Algonquin/Stantec Open House – Dec. 6th 2011.

Turbine Noise: A Report from the Association to Protect Amherst Island

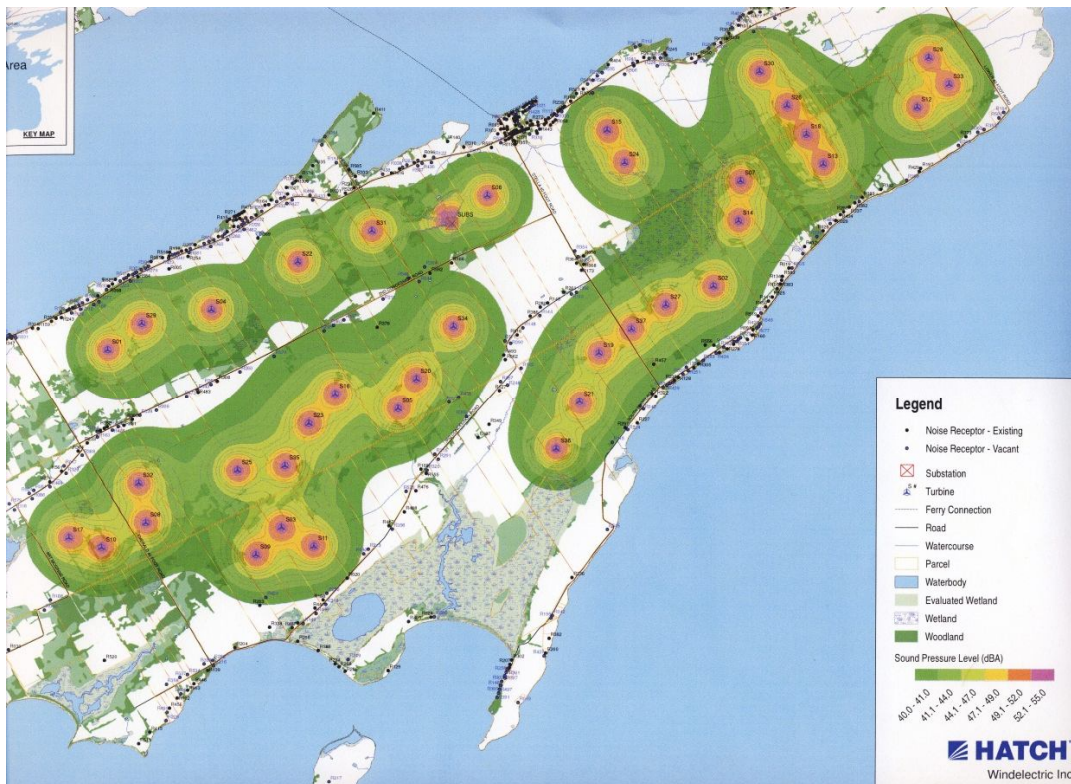
Comment: Attention to all of the above will save Algonquin from itself. Algonquin and Stantec have sited the turbines so that the majority of homes are very close to the 40 dBA noise limit. The 40 dBA prediction is in reality a prediction of 40 ± 4 dBA; that is the range 36 to 44 dBA. We can therefore expect that a significant number of homes will have a sound pressure level above 40 dBA. They will be out of compliance and will be shut down. This lack of compliance will be exacerbated by c) and d) above.

- a) The 40 dBA is a predicted noise level for turbine noise but a measured noise level for road or industrial noise. There are good reasons for believing that the predictions under-estimate the actual noise.
- b) The periodic nature of turbine noise (the swoosh-swoosh-swoosh) draws attention to the noise. Although the Ministry of the Environment has a regulation that applies a penalty of 5 dBA to noise of a periodic nature, it specifically excludes turbine noise from the penalty. That does not, of course, mean that turbine noise does not deserve the penalty!
- c) The predicted noise level carries with it an uncertainty of ± 4 dBA. Therefore, a prediction of 40 dBA really means a noise level most probably in the range 36 to 44 dBA. The figure, taken from the APCo/Stantec website shows the predicted noise contour map for the project.

Note the large number of residences at or close to the 40 dBA contour, the outer-most contour. At many of those residences, turbines will be non-compliant even without consideration of the problems discussed below.

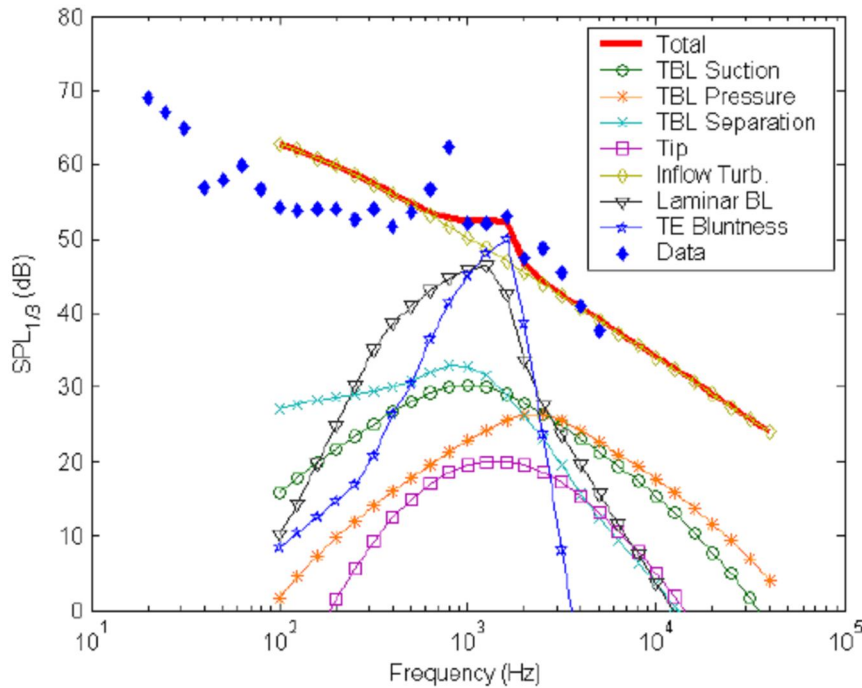
e) Hatch has ignored the extra noise caused by turbulent inflow to the turbine. This is widely recognized as an aerodynamic noise source but as yet is not required to be considered by MOE. Nevertheless it is a real contribution and its neglect will jeopardize APCo when it comes to a noise audit. For APCo's development the risk is heightened by the excess turbulence that will result from the very high density of turbines. Every turbine creates a turbulent wake. Most of the turbines planned for Amherst Island are within 5 or 6 blade diameters of an upwind turbine for the prevailing wind direction. Of particular concern is that turbulent inflow noise is primarily low frequency noise and dominates the total turbine noise below 500 Hz. Low frequency noise is not absorbed by the atmosphere and is especially annoying.

The figure illustrates predicted and measured turbine noise for a research turbine at the National Renewable Energy Laboratory in the USA. The blue diamonds show the measured noise. The yellow triangles show the predicted turbulent inflow noise. The turbulent intensity was 22%, relatively high. However, at a more typical turbulent intensity of 10%, the turbulent inflow noise would be only 6 dBA lower. The actual magnitude of the noise is not relevant here; the figure demonstrates the relative importance of a source of noise ignored by Hatch and MOE.

Figure 2: Sound Levels Measured at the Lormand Residence. Comparison to Wind Speeds and Criteria. Canadian Hydro, Melancthon EcoPower Center.

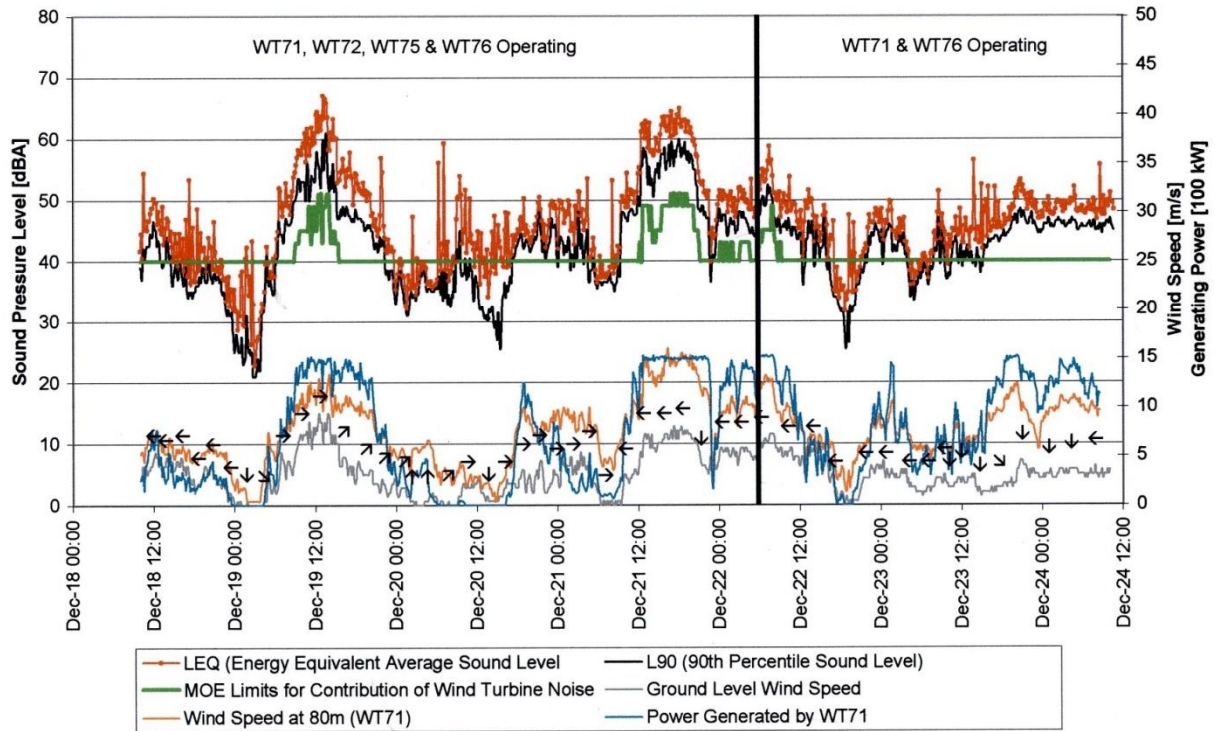
This project had been approved by MOE but under earlier guidelines which allowed the turbine noise at a residence to rise from 40 dBA at a wind speed of 6 m/s to 51 dBA at a wind speed of 10 m/s. The red line is the turbine noise at the residence. The green line is the MOE noise limit. The difference is up to 15 dBA; clearly the turbine noise was non-compliant. In this case, the family agreed to a buy-out of their home. Transalta bought out several homes. Under the 2008 MOE regulations developers have lost the ability to go above 40 dBA.
